Piper Aircraft, Inc.
2926 Piper Drive
Vero Beach, FL, U.S.A. 32960

SERVICE NO. 1355B BULLETIN

TEE BAR ASSEMBLY INSPECTION

SB 1355B removes an erroneous note from the Compliance Time section.

Figure 1
Tee Bar Assembly – Weldment

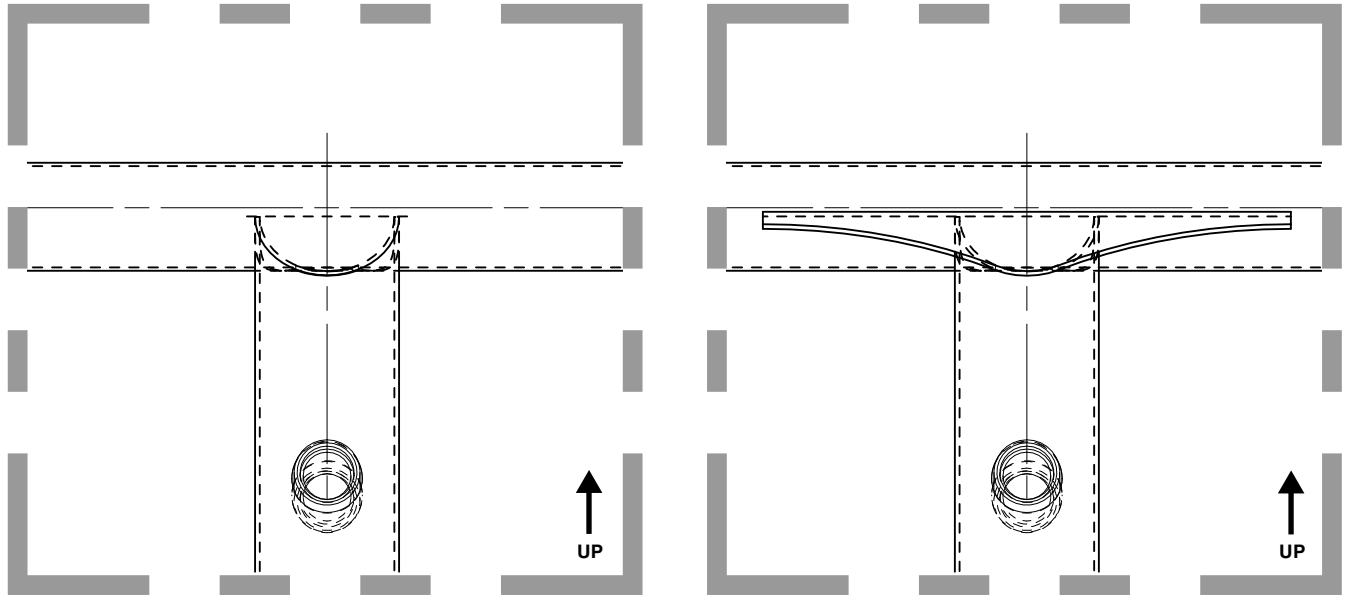
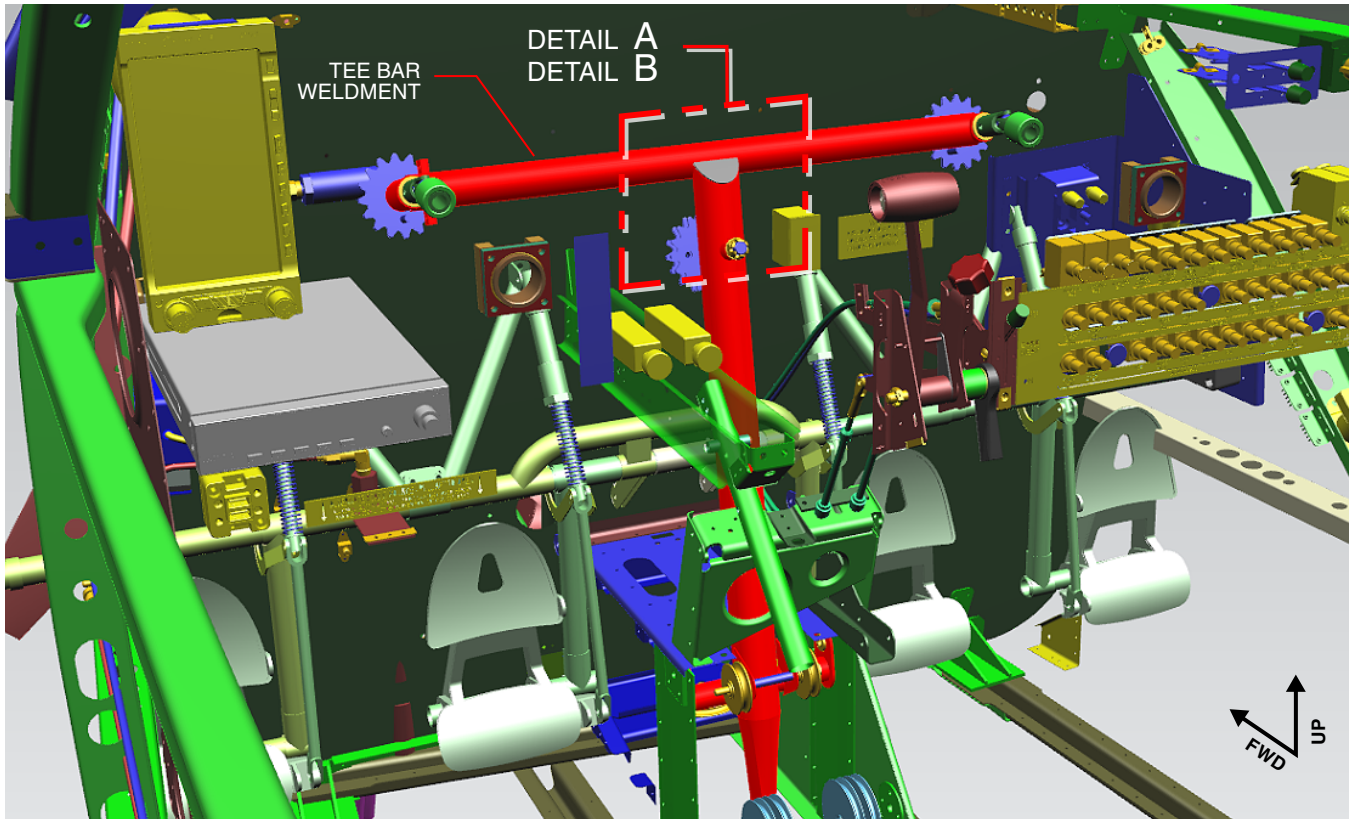
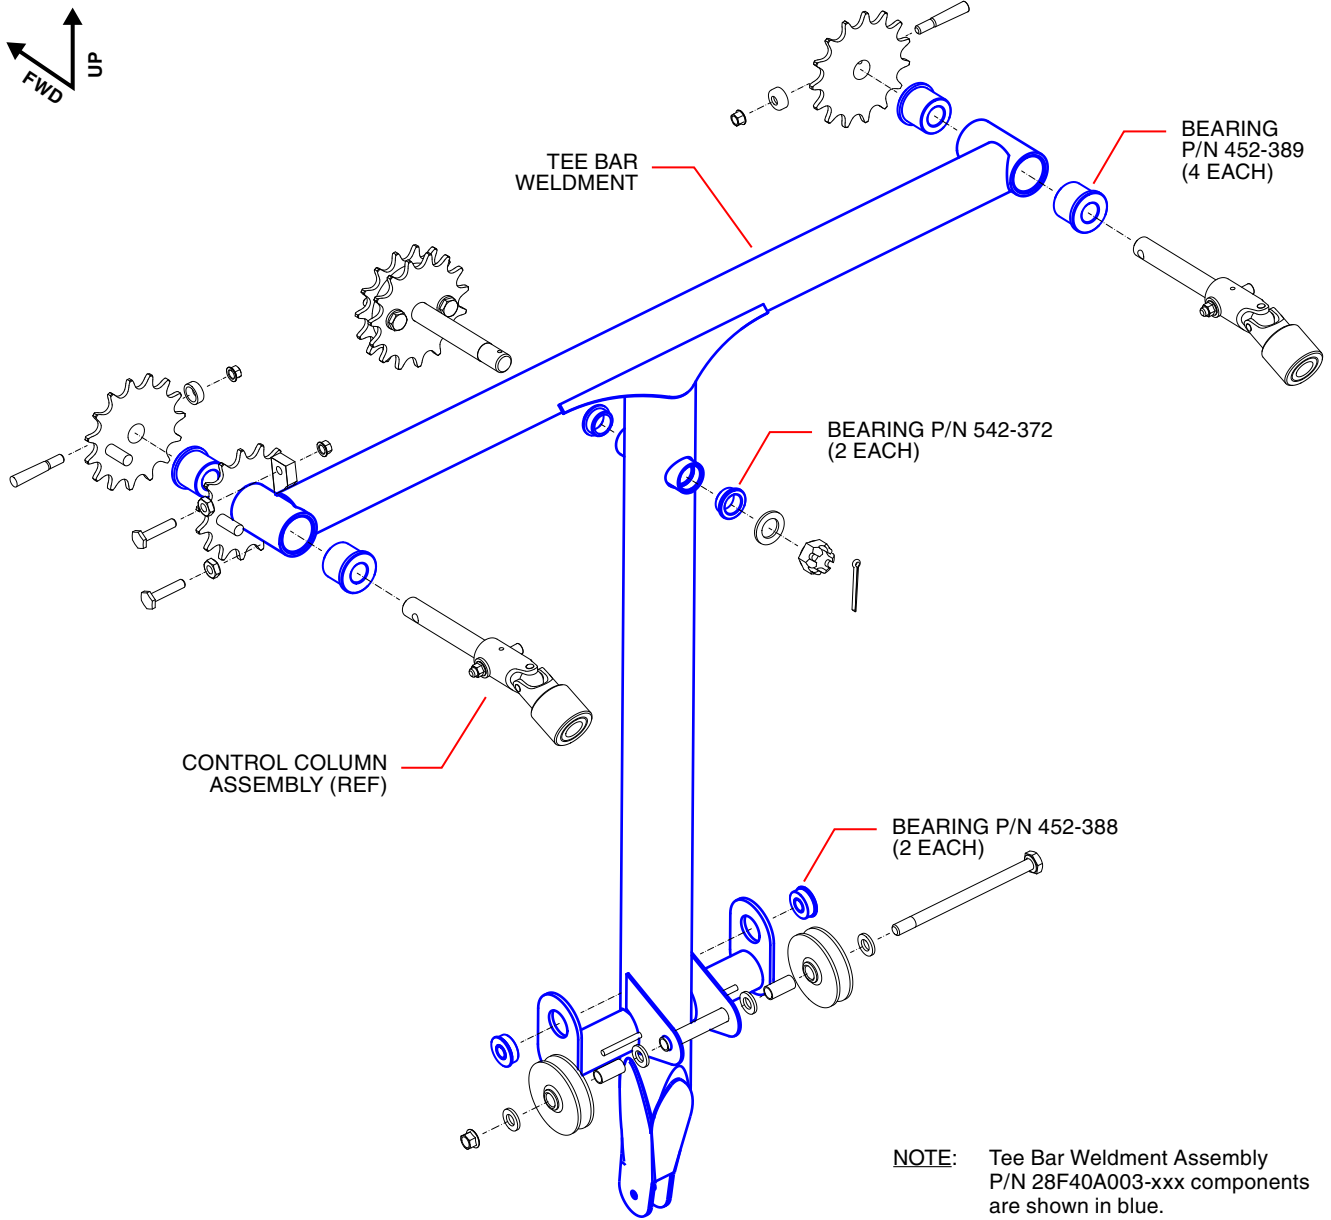
1. Gain visual access to the top center portion of the tee bar assembly, as shown in Figure 1. Identify the configuration of the tee bar weldment assembly.
 - If the local area conforms to Figure 1, Detail A, then recurring inspections are required. Proceed to Step 2.
 - If the local area conforms to Figure 1, Detail B, then the factory original tee bar assembly has already been replaced with a tee bar assembly containing the required features (i.e., gusset) and is already in compliance with Part II. Therefore, no recurring inspections are required. Proceed to Part II, Step 8.

2. Examine the area shown in Detail A for cracks, with special emphasis on welded joints.

- a. If the paint is cracked, chipped or peeled in the vicinity of the inspection areas, or if there is evidence of corrosion (such as staining or blistering), then a fluorescent penetrant inspection is required as described in Step b, below. Prepare the surface by removing the paint using Cee-Bee A-202 paint stripper, or an equivalent. Wipe off any residue, in the areas where the paint was removed, with isopropyl alcohol.

- b. Perform a fluorescent dye penetrant inspection per FAA Advisory Circular AC 43.13-1B, Chapter 5, Section 5.
 - If any cracks are discovered, then the tee bar weldment must be replaced prior to next flight. Proceed to Part II.
 - If no cracks are discovered, apply primer and topcoat to bare metal, per the applicable Piper Airplane Maintenance Manual (AMM) or Service Manual (SM) and FAA Advisory Circular AC 43.13-1B, Chapter 6. Proceed to Step 3.

Figure 3
Brass Shim P/N 62833-152 Installation Location

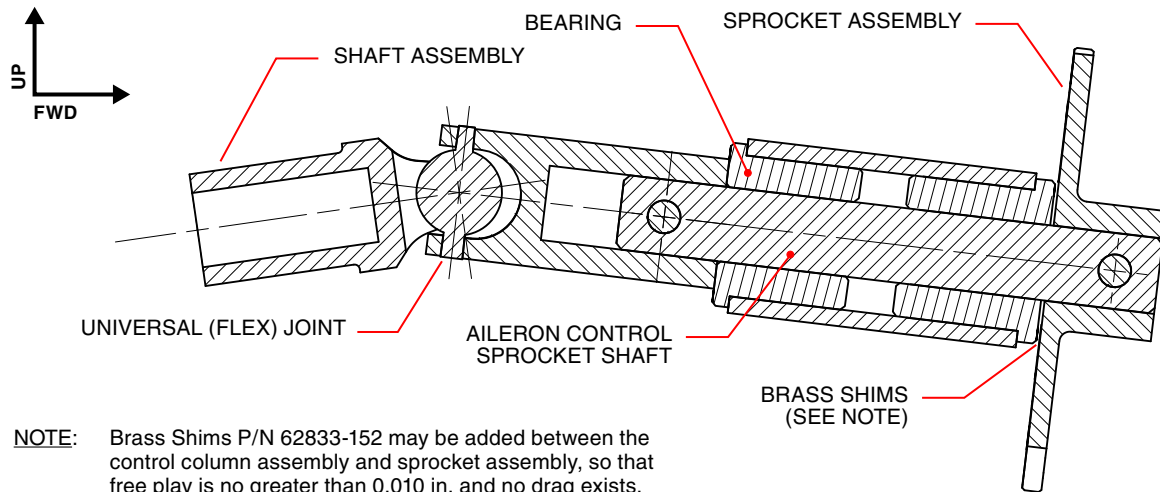
5. Reinstall the control column tee bar assembly and control wheel columns, in accordance with Section 27-10-00 of the applicable Piper AMM or Section V of the applicable SM. If necessary, so that there is no greater than 0.010 in. of free play (relative motion) and no drag exists between the control columns and sprocket assemblies, add Brass Shims, Piper P/N 62833-152, no more than two (2) per side, as shown in Figure 3.
